State Water Resources Control Board

CONDITIONAL APPROVAL OF THE WESTERN FIBERGLASS UNDER DISPENSER TRANSITION FRAME, AS AN UNDER DISPENSER SPILL CONTAINMENT OR CONTROL SYSTEM (UDSCCS)

**RE: UNDER-DISPENSER SPILL CONTAINMENT OR CONTROL SYSTEM
WESTERN FIBERGLASS
UDC TRANSITION CONTAINMENT FRAME
FIBERGLASS VERSION AND FLEXIBLE VERSION**

DESCRIPTION
**DISPENSER MOUNTING ASSEMBLY
 WITH RETROFIT SPLASHGUARD**

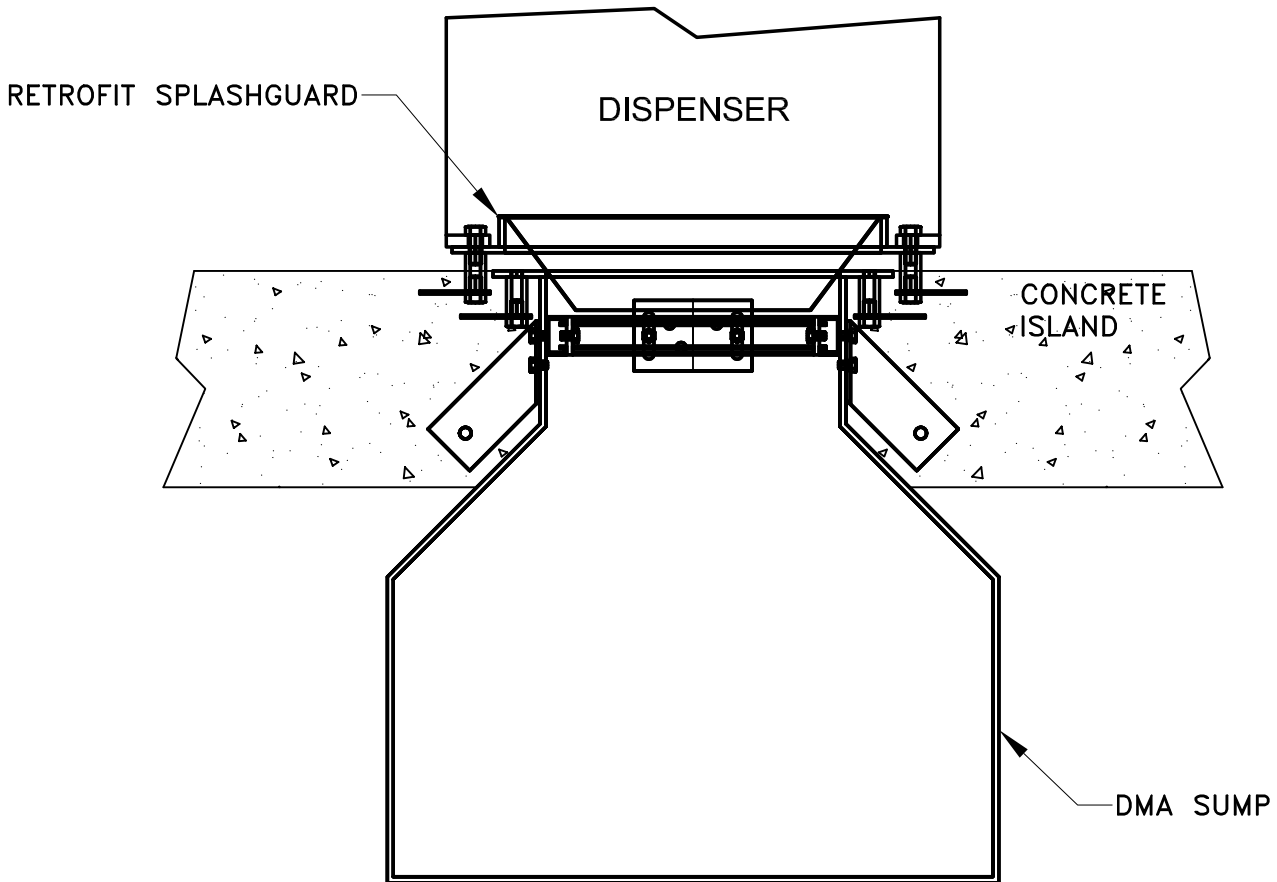
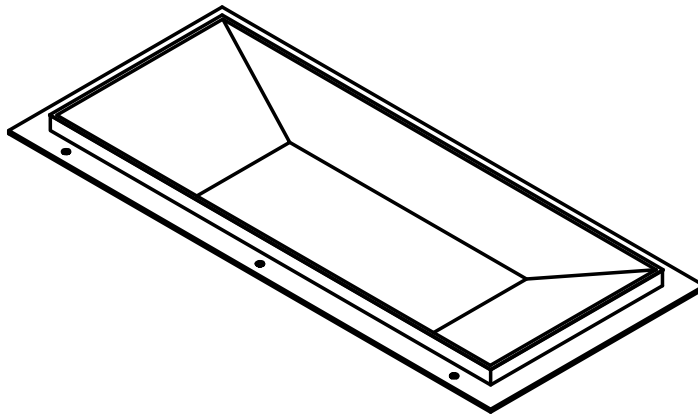
1. This model comes in several sizes in order to accommodate various dimensions of UDC and dispenser. Schematics and molds of all existing and future sizes for the Western Fiberglass Under Dispenser Transition Frame shall be made available upon request of the State Water Board.

11. The Western Fiberglass Under Dispenser Transition Frame shall not carry the load of the dispenser and shall not interfere with the installation requirements specified by the dispenser manufacturer. This approval in no way relieves the manufacturer or installer from responsibility for ensuring that the dispenser is properly secured in accordance with applicable codes, regulations, dispenser manufacturers installation instructions, and sound engineering practice.
